Your ref.:
CDM Ref 3142

Date:
11 May 2010

**Response to requests for review of project activity 3142
“Roaring 40’s Wind Farms (Khandke) Private Limited”**

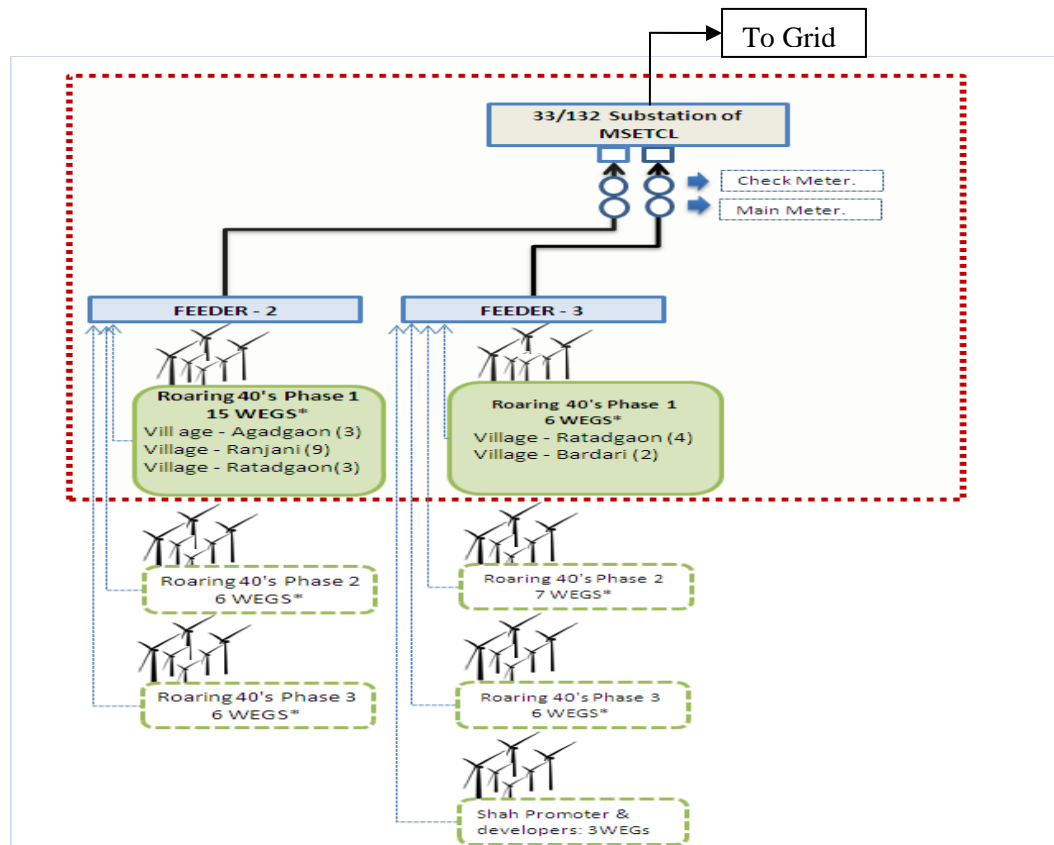
***Question 2:** The DOE is requested to further validate how the monitoring of each of the wind farms located in the four villages will be carried out in line with VVM ver1, paragraph 121.*

At the time of validation visit was conducted by DNV (on 04-07 July 2007) only phase I machines (project activity) were commissioned (only 12 out of 21 machines). DNV confirmed from the project participant and MSEDCL representatives (a distribution wing of Maharashtra state electricity board) that each phase machines will be connected to individual meter (feeder-2 and feeder 3 meter in case of project activity). However, later in 2008 and in 2009 when the phase II and phase III machines were commissioned, these machines along with 3 machines of another investor (shah promoter) were also connected to same energy meters (feeder -2 energy meter (machines installed at Agadgaon, Ranjani & Ratadgaon villages) & feeder-3 energy meter (machines installed at Ratadgaon and Bardari villages)).

DNV confirms that the current metering arrangement for the project activity meets the requirement of the applied methodology (ACM0002 version 09) which requires electricity supplied to the grid by the project activity need to be monitored (difference of electricity exported and imported to/from grid, both measured). In case of the project activity, the total electricity exported and imported to/from grid (from the WEGs connected to feeder-2 and 3) are measured through Main Meter (04880814-feeder 2 and 04880816- feeder 3) and check meter (04880814-feeder 2 and 04880817- feeder 3). Joint meter readings of these meters (main meter 04880814 and check meter 04880814 for feeder 2 and main meter 04880816 and check meter 04880817 for feeder 3) are conducted every month by MSEDCL (distribution wing of Maharashtra state electricity board) in the presence of Enercon India Limited (O&M contractor for wind farm). The electricity export and import from the WEGs connected to the feeder 2 and feeder 3 is apportioned based on the on LCS meter readings available from the individual WEGs (provided by Enercon the O&M contractor). The procedure for apportioning has been provided under Annex 4 of this response. The electricity imported to/from grid from the WEGs connected (15 machines of feeder 2 and 6 machines of feeder 3) to the project activity is taken from the energy breakup report certified by MSEDCL, against which the project proponent raises invoice to MSEDCL. The invoices can be used for the double checking purposes as per the requirement of the methodology.

The main (04880814-feeder 2 and 04880816- feeder 3) and the check meter (04880814- feeder 2 and 04880817- feeder 3), installed at substation are of 0.2 accuracy class and will be calibrated by MSEDCL on annual basis. The QA/QC procedures for apportioning (based on individual WTGs connected to feeder 2 and 3) as described in Annex-4 of this response.

The metering arrangement at feeder 2 and feeder 3 has been provided in the schematic diagram below:
